REPORT DOCUMENTATION PAGE		READ INSTRUCTIONS BEFORE COMPLETING FORM
1. REPORT NUMBER	2. GOVT ACCESSION NO.	3. RECIPIENT'S CATALOG NUMBER
4. TITLE (and Subtitle) A PRELIMINARY HUMAN ENGINEERING EVALUATION OF HYPERBARIC CONTROL SYSTEMS.		5. TYPE OF REPORT & PERIOD COVERED Medical Research Progress Report.

**A PRELIMINARY HUMAN ENGINEERING EVALUATION
OF HYPERBARIC CONTROL SYSTEMS**

The information to be reported emanates from a preliminary evaluation dealing with human factors design adequacy of hyperbaric control/displays developed for the hyperbaric research facility. Although the control-panel designs had been approved and fabrication was underway, a preliminary review of the engineering diagrams for the control panel revealed that the existing designs might contribute significantly to decrements in overall system performance: a thorough human factors engineering analysis appeared to be required. The scope of this report is limited to an analysis of the instrumentation/man interface.

Fig. 14. Example of poor task-loading decision.

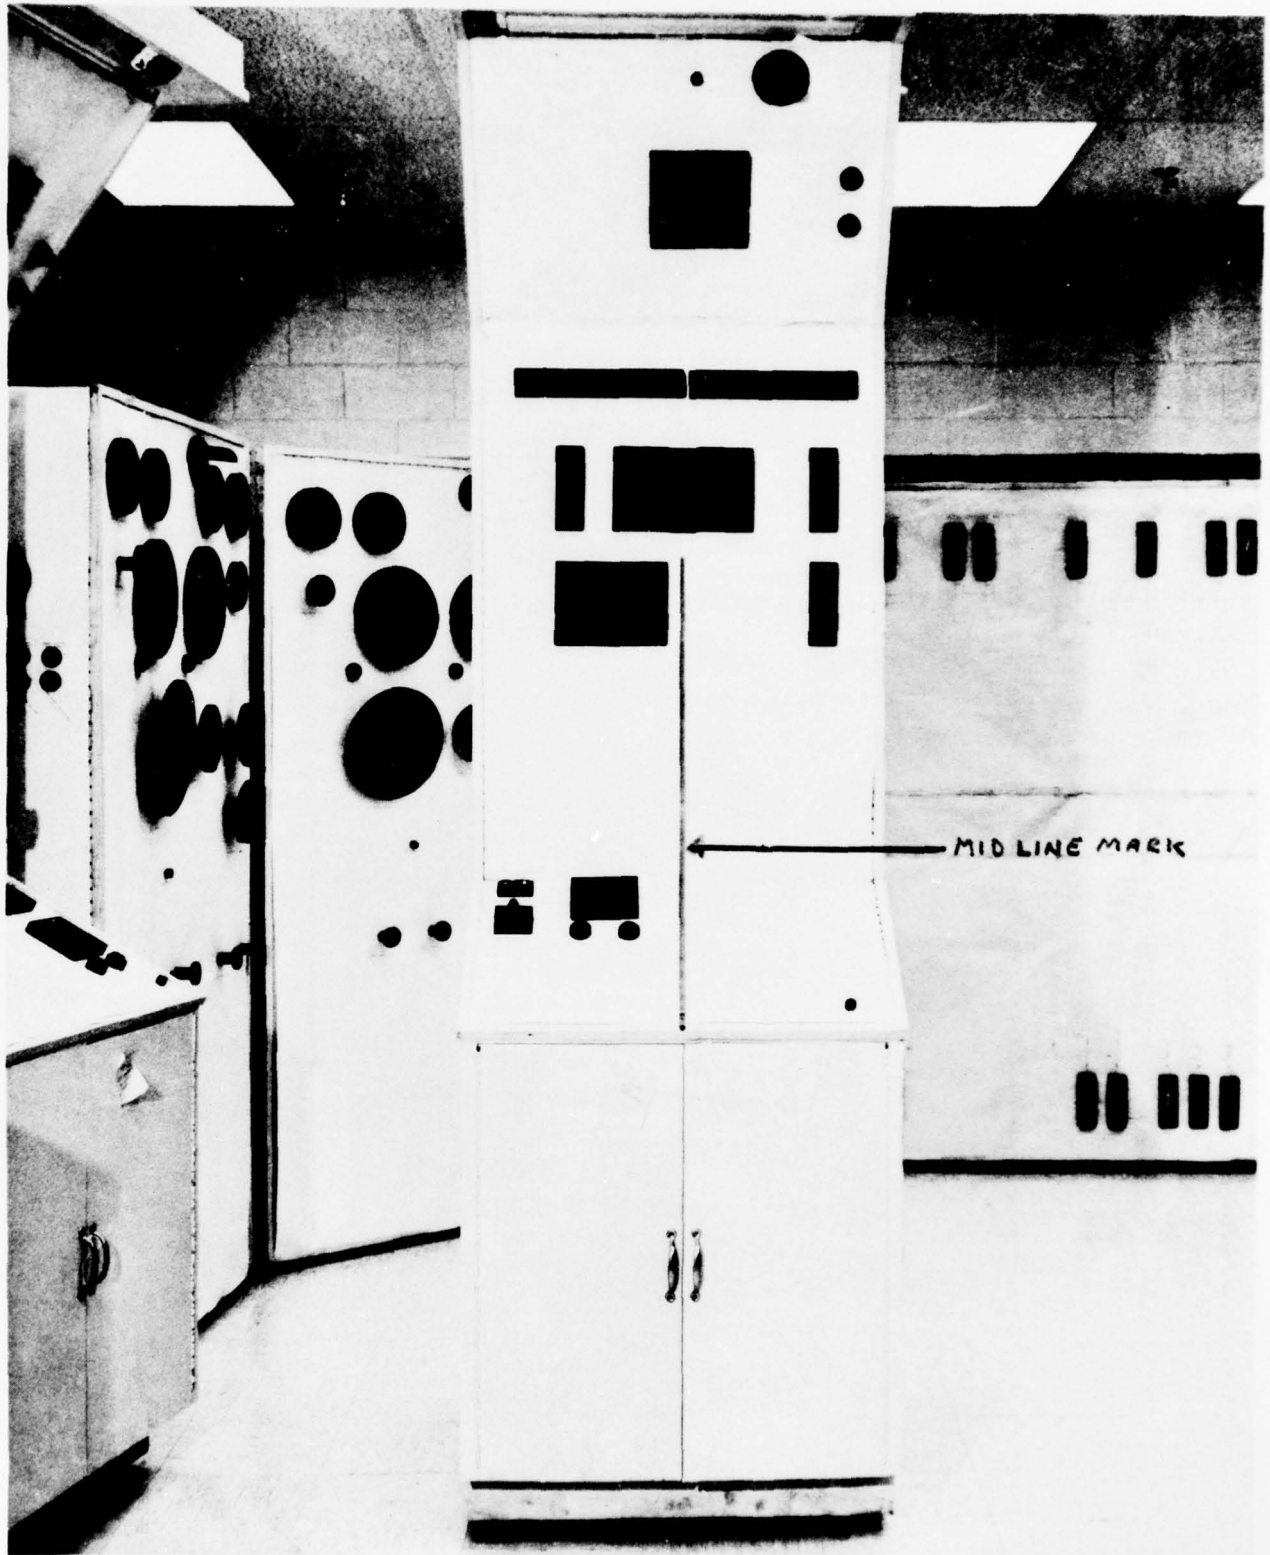
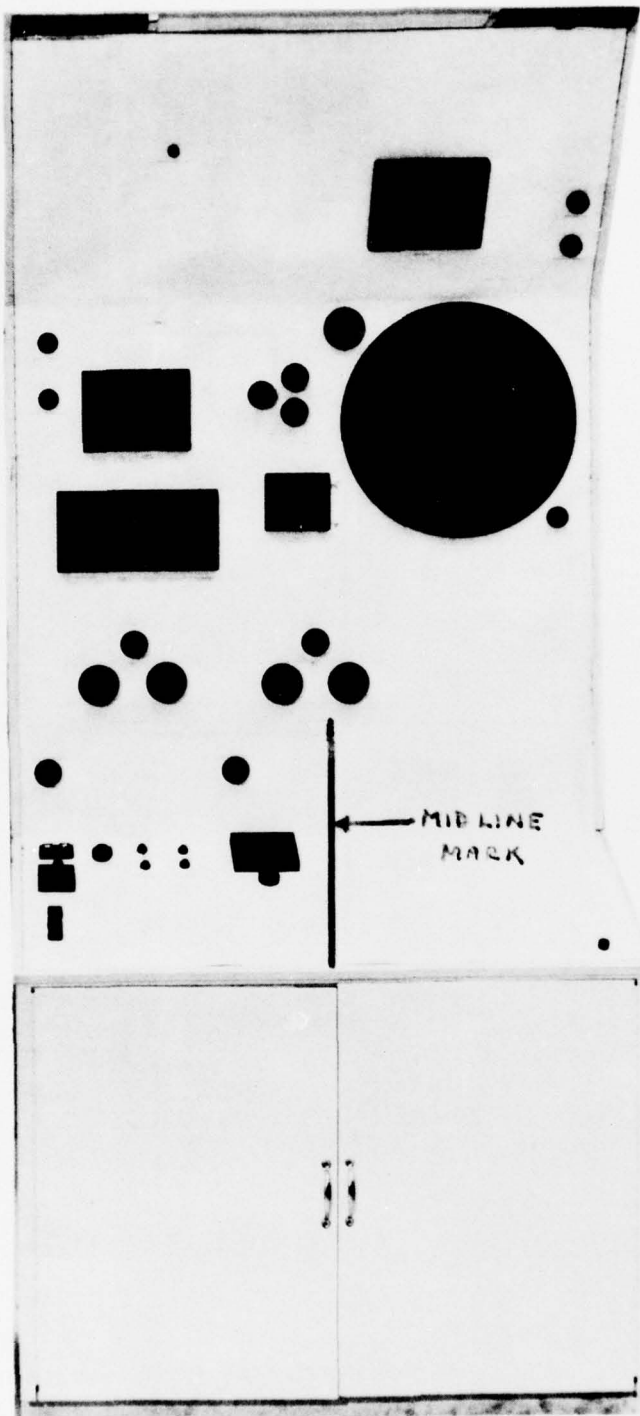
Figures 14 and 15 show a similar situation where all five functional controls are situated to the left of the panel midline mark. These panels present more of the work task to the left hand of a control-panel operator. It is therefore recommended that controls be convenient to the operator's right hand, which shares the larger portion of the control task. Control placement should also be dictated by the priority of task function, where high priority and frequently used components would be located in the upper-right quadrant or the most easily accessible area of a panel. Frequency-of-use studies will be conducted in the near future and the results will be published for use.

Fig. 16. The placement of the O_2 manifold in relationship to the O_2 meter is shown (panels #3007870 and #3007872).

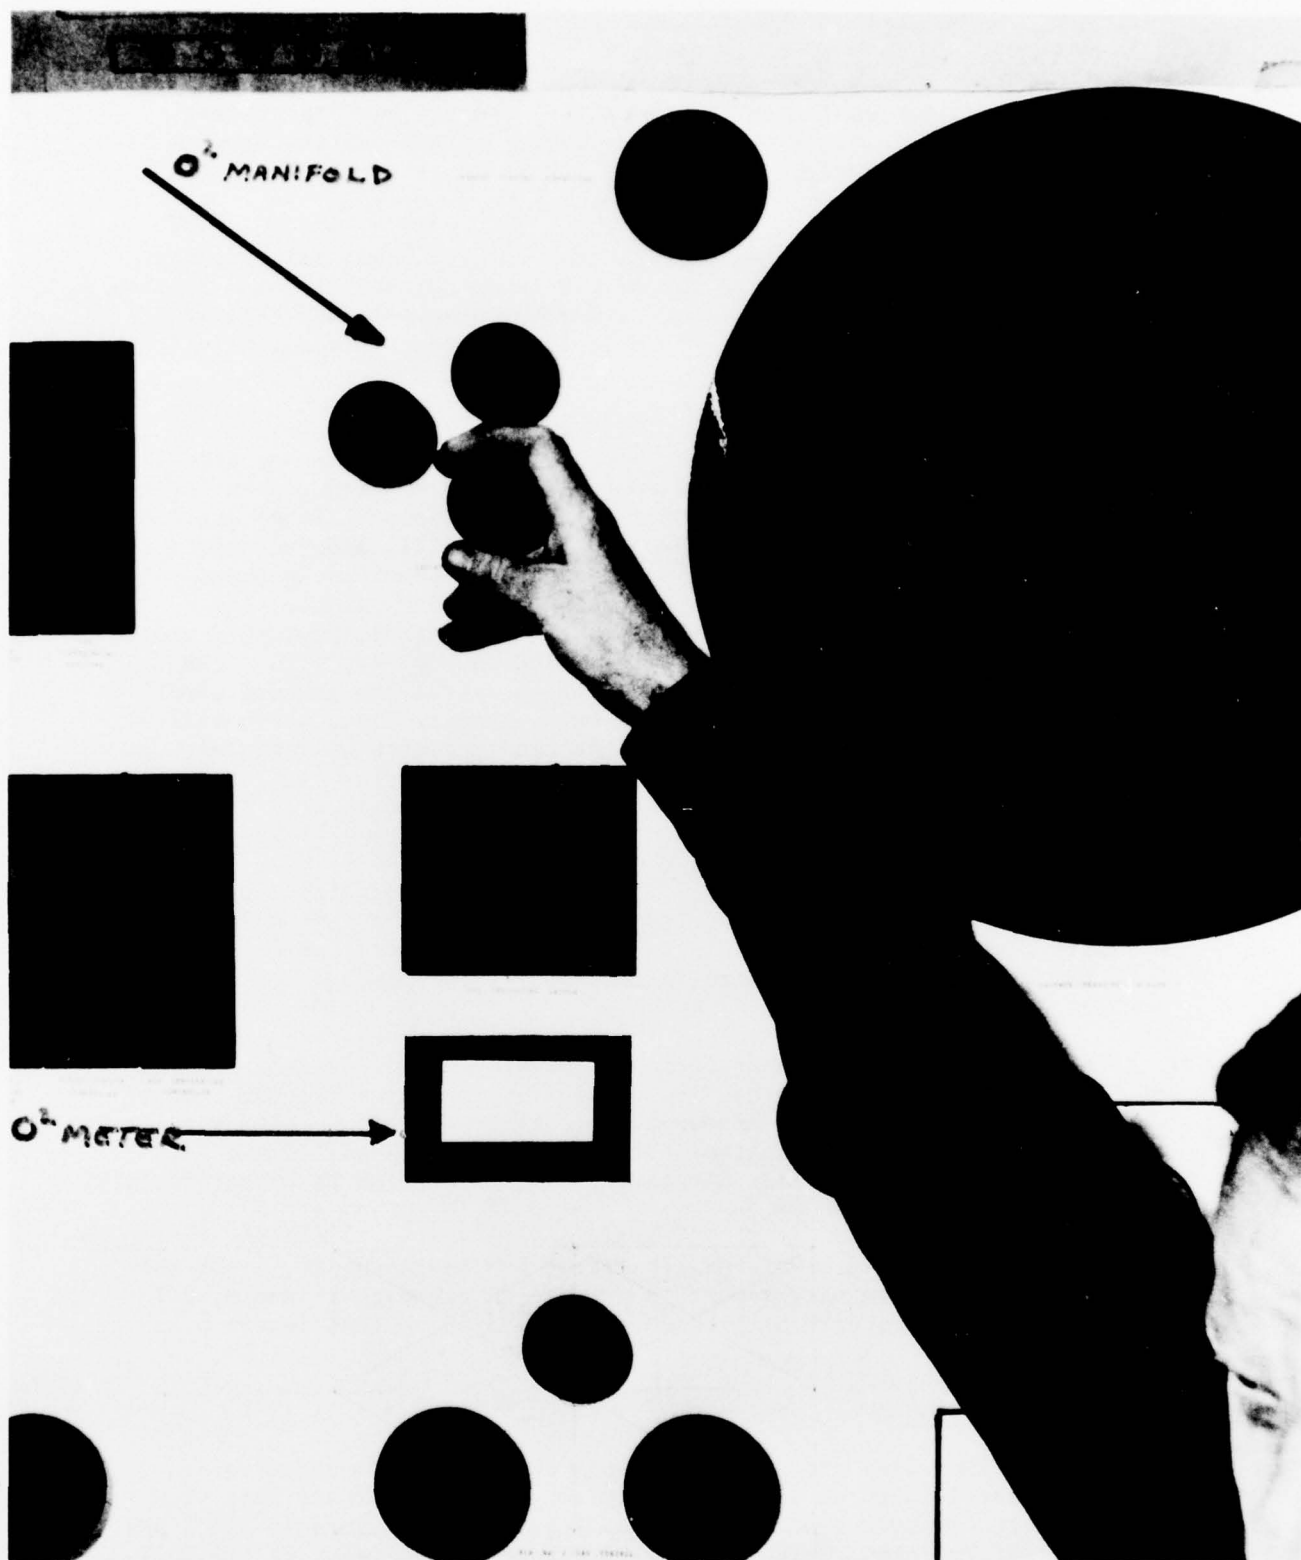
The oxygen manifold is part of the oxygen make-up system. It consists of one bypass and two isolation valves; it is used to add oxygen to the chamber in a predetermined concentration. This system (Fig. 16) is manually operated and provides visual information to the operator via the oxygen-level controller, which is a display meter. This meter gives the operator time-delayed feedback as to the percentage of oxygen in the hyperbaric chamber.

Six experienced Navy divers were asked to turn the valves of the oxygen manifold and report on the ease or difficulty of this operation as it relates to the clearance of their fingers/knuckles. Figure 16 provides an illustration of this operation. Five of these six diver subjects reported that the spacing between these valves (1) retarded their efforts, (2) caused unwanted contact with one or more other valves, and (3) required that they orient their wrist/arm in an unnatural position. In addition, two of these six divers (5 feet 6 inches and 5 feet 7 inches in height) reported that the oxygen manifold was placed too high on the panel relative to its associated importance. Although these reports were subjective, virtually all of these six divers were observed

to come in physical contact with valves they did not plan to operate while they were attempting to move any given component on the oxygen manifold. This observation would appear to validate a portion of the diver reports.

It should also be pointed out that the corresponding relationship between the oxygen manifold and the oxygen-level controller meter (bottom arrow on Fig. 16) is not optimized. A further discussion of this is found under the section of this paper labeled "Control-Display Relationships."

Fig. 18. MRCC panel #337870: The components of the environmental control system labeled A, B, and C are displayed. Note that they are not grouped together, but are separated by 23 inches. In addition, controls A and B appear to comprise part of the BIB gas meter controls.

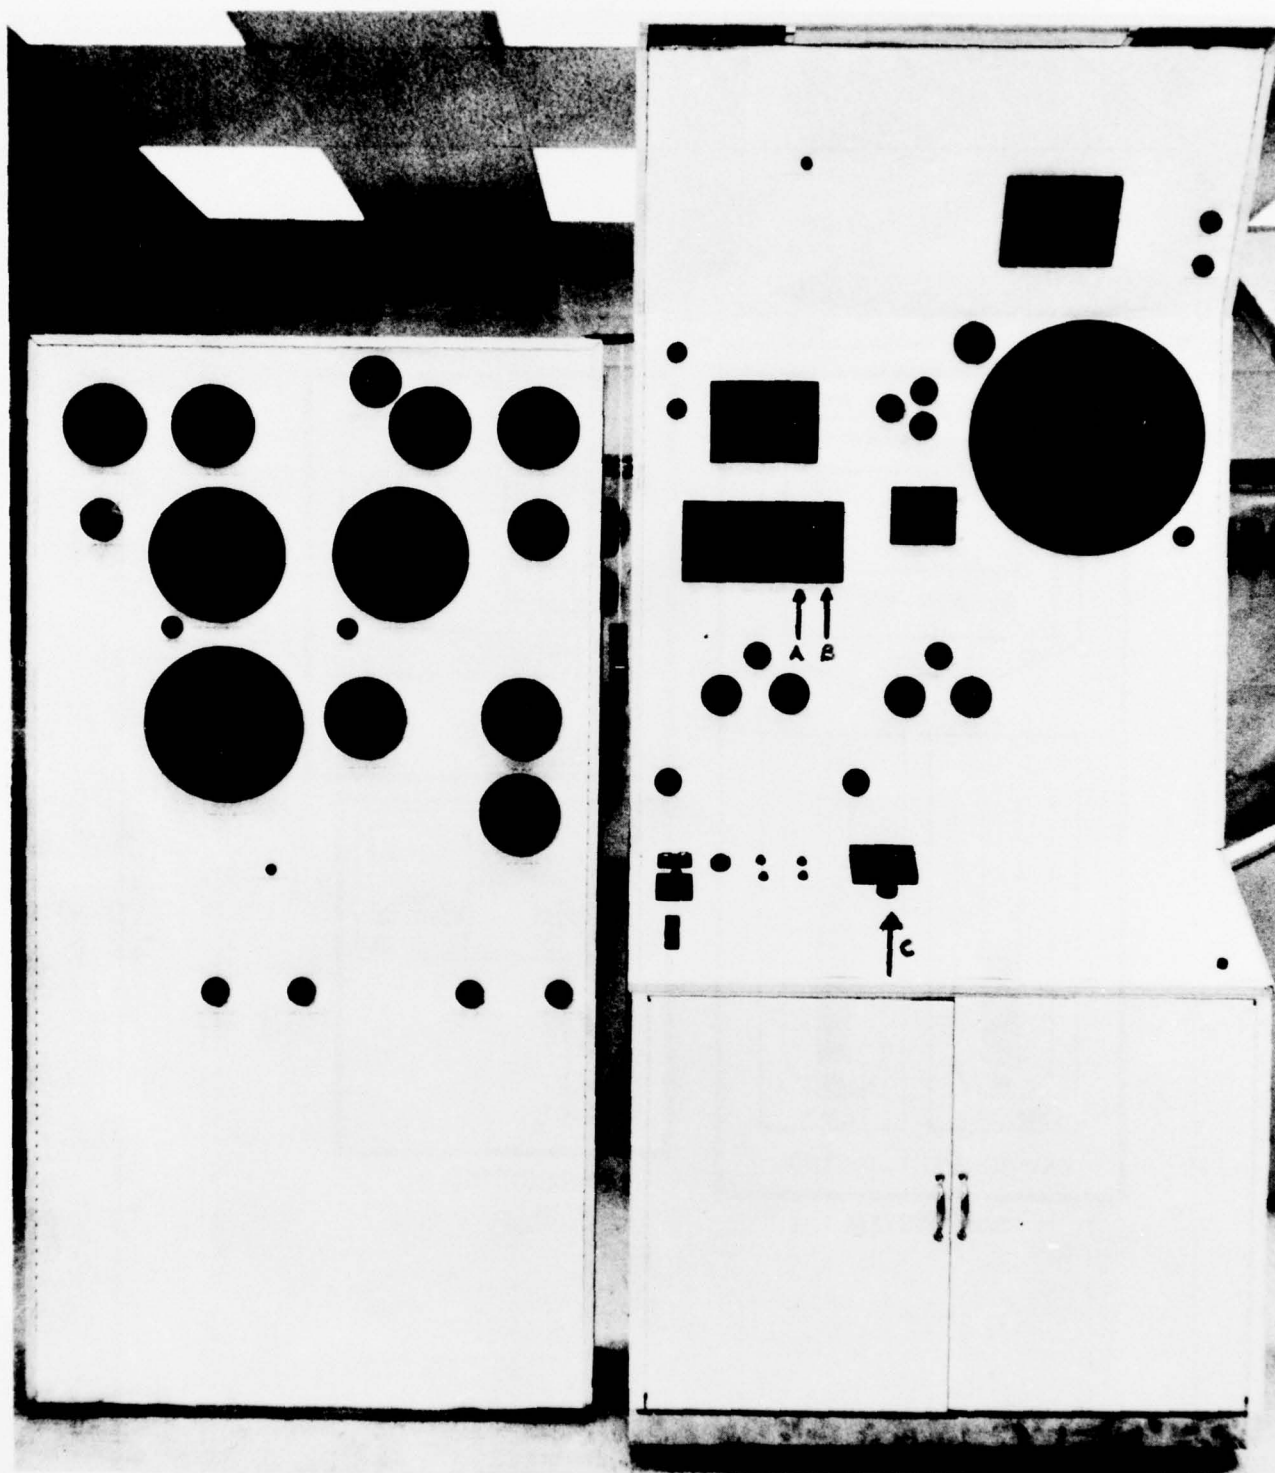
In comparison, however, Fig. 18 indicates three similar components of the MRCC panel, which are labeled A, B, and C. Component A is the humidity control/indicator; B is the temperature control/indicator, and C is the blower fan/speed control/indicator for the atmospheric-conditioning system (ACS).

Although these components form part of the internal weather system of the hyperbaric chamber, they are physically separated by over 2 feet. Components A and B give the appearance of being part of the BIB pressure and mixed-gas indicators (to the left of the arrows labeled B and A), but their function is totally unrelated. This situation is unsatisfactory for the reasons given above.

Fig. 20. A seated diver unable to reach selected control panel #3007875 is shown.

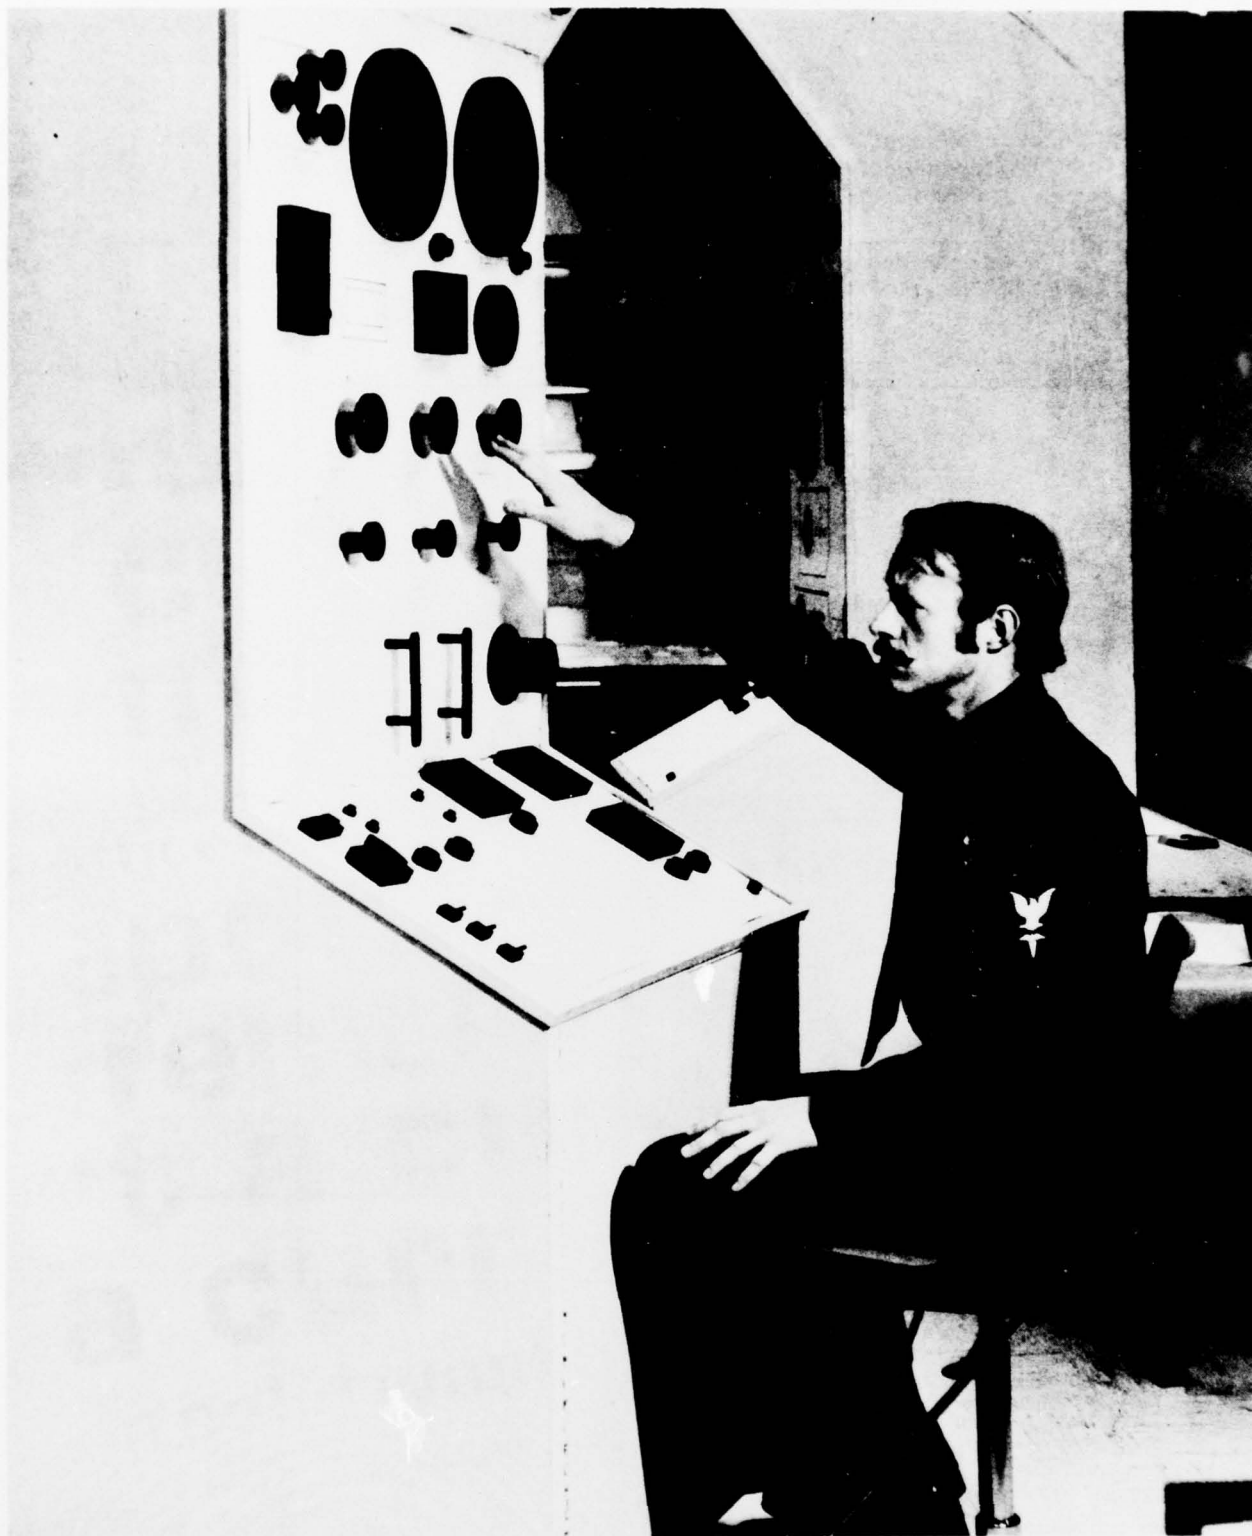
Specifications (MIL-STD-1472A, 1970), and which was acceptable to Navy divers in the 5th through 95th percentile-height (Beatty and Berghage, 1972). When this seating arrangement was used as a criterion model, none of the existing control panel mock-ups under evaluation was satisfactory. For example, it was empirically determined that the 75th percentile Navy diver had access to less than an average of 64% of the controls from a seated position when Reference A (see Fig. 13) was extended to a full 22 inches. Even when the mock-ups were examined with the diver in a standing position, they were poorly instrumented from the standpoint of accessibility.

Table 1 displays the percentage of controls reached by both standing and seated control operators. Note that the range of accessibility from the standing position was 70% to 80%. The seated operator has much more difficulty: the percentage range averaged from 48% to 74% for the 5th, 25th, 50th, 75th, and 95th percentile-height operators. Figure 20 shows a seated diver at one control panel. He is representative of the 65th percentile Navy diver in height. When asked to reach for each control without stretching, only 50% of the controls were in his reach or in a good field of view. Even when the seat was raised from 18 inches to 29 inches (see Fig. 21) and the diver was asked to stretch his reach as far as possible, 6 control functions were still out of his reach.

It is suggested that the control panels be modified to accommodate the seated operator. As a minimum requirement, the controls should be repositioned so that Navy divers in the 25th to 75th percentile-height range have unobstructed access to at least 80% of all control functions from the seated position. One solution would be to mount controls on a horizontal wrap-around console. In this manner the access area of the panel control surface would be increased by a greater factor compared to present designs (see Fig. 22).
